Job Name	Cheshunt Football Club
Subject	Transport Note
Ref	18086/N01
Date	5 November 2019

- KMC is appointed by LW Developments Limited to provide transport advice for the
  proposed development of Cheshunt Football Club. This note has been prepared in response
  to a highway objection received by Hertfordshire County Council (HCC) highway authority for
  application reference 07/18/0514/F. The comments made by HCC can be summarised under
  the following headings:
  - Pedestrian and cycle movement and access;
  - Refuse vehicle swept path analysis;
  - Accident analysis; and
  - Highway impact assessment.
- 2. This note responds to each of the comments raised in turn under the above headings.

Figure 1 – Personal Injury Collisions (PICs) for latest 5 years

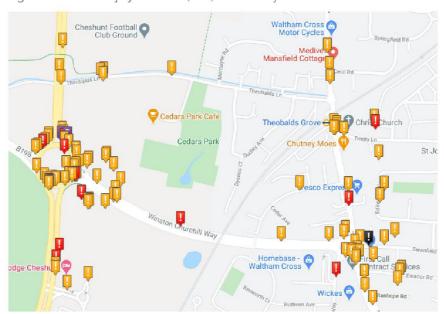
- 10. The Transport Assessment that was prepared to support the application included a summary of personal injury collision data (PIC) for the 5 years period up to the end of June 2017. HCC has requested that up to date PIC data is assessed to determine if there are any accident issues within the study area.

- 12. Accident data for the most recent 5 year period has been sought from the Crashmap database, which summarises the Personal Injury Collisions (PICs) for the surrounding highway network. Figure 1 below summarises the PIC data.

13. Table 3 below summarises the updated PIC data for the junctions and links within the study area. The numbers in brackets are the PICs that were assessed as part of the Transport Assessment.

- 14. The table shows that the most recent PICs within the area are either the same number and severity as previously assessed in the Transport Assessment or have reduced with the only exception being a fatality in the vicinity of the A121/High Street/Swanfield Road roundabout, which occurred in December 2018. The fatality occurred in dark and wet conditions and involved a vehicle colliding with pedestrian, who was fatally injured.
- 15. It is considered that the same conclusions can be reached as within the Transport Assessment and that there are no inherent road safety deficiencies in the highway network in the vicinity of the site.
